FOUNDATION INVESTIGATION REPORT
For
Hwy. #604 - Township of Jaffray
District No. 20 (Kenora)
W.O. 71-11020 -- W.P. 55-69-01

SWAMP INVESTIGATION

BORE HOLE LOCATIONS & SOIL STRATA

✓ 71-11-020
W.P. 55-69-01
Secondary Highway 604
0.5 Miles East of Kenora E. Lts.,
N'ely. to end of Highway
District 20 - Kenora

AREA 2

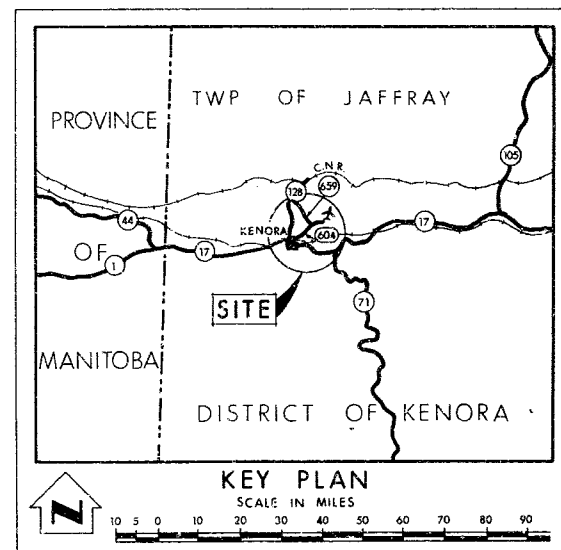
The Foundation Investigation into three swamp crossings on the above mentioned work project was reported on June 29, 1971. The treatments recommended in this report at Areas 1 and 2 while suitable, appear to me to be rather excessive for this class of highway.

I would recommend that you review the treatment in these two areas and consider alternative solutions such as the lowering of the grade or possibly realignment as a means of making these crossings. Either of these treatments should be more economical and in keeping with the function of the road proposed.
